# SERVICE NO. 1375 BULLETIN

Date: March 31, 2022

### PERIODIC REPLACEMENT OF MAIN LANDING GEAR ATTACHMENT HARDWARE

**Figure 1**  
Main Landing Gear – Mounting Hardware

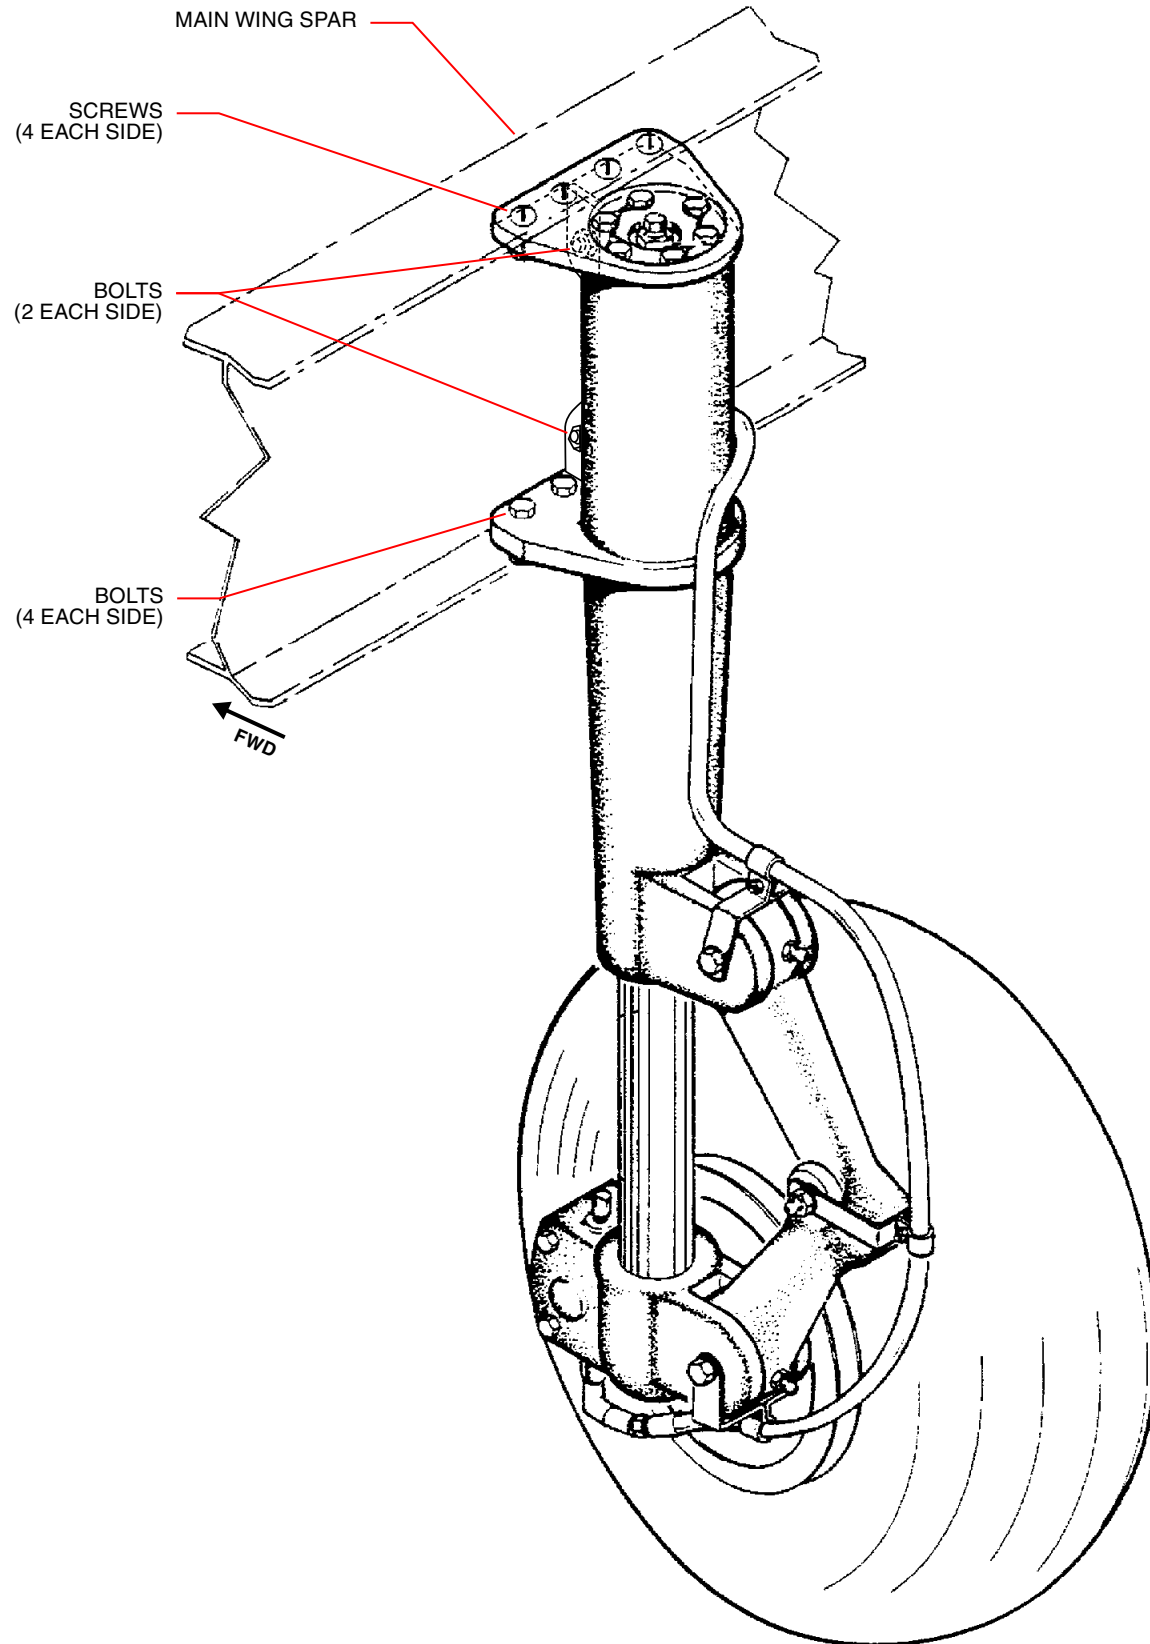
A review of service history reveals that for the affected aircraft, the landing gear mounting hardware is subject to metal fatigue and corrosion. Failure of this hardware could result in a landing gear collapse.

The main landing gear (MLG) are attached to the aircraft with threaded fasteners that pass through mounting flanges on the strut cylinder and the upper and lower flanges of the main wing spar, as depicted in the illustration below. On some of the affected aircraft, additional threaded fasteners pass through the web of the main wing spar.

1. Place the aircraft on jacks.
2. Remove the fairing from around the cylinder housing and the access plate located on the bottom of the wing and to the rear of the housing by removing attaching screws.
3. Remove and discard all of the threaded fastener stack ups (which includes screws and bolts, as well as nuts and washers) that attach the MLG to the main wing spar. (See Figure 1.)
4. Inspect mounting holes and mating surfaces of MLG and main wing spar for damage, and repair or replace on condition.

5. Order and install new mounting hardware, as specified in the applicable Piper Airplane Parts Catalog (IPC).
6. Reinstall the access plate onto the bottom of the wing and the fairing that surrounds the cylinder housing.
7. Remove the airplane from jacks.
8. Make a logbook entry documenting compliance with this service bulletin.
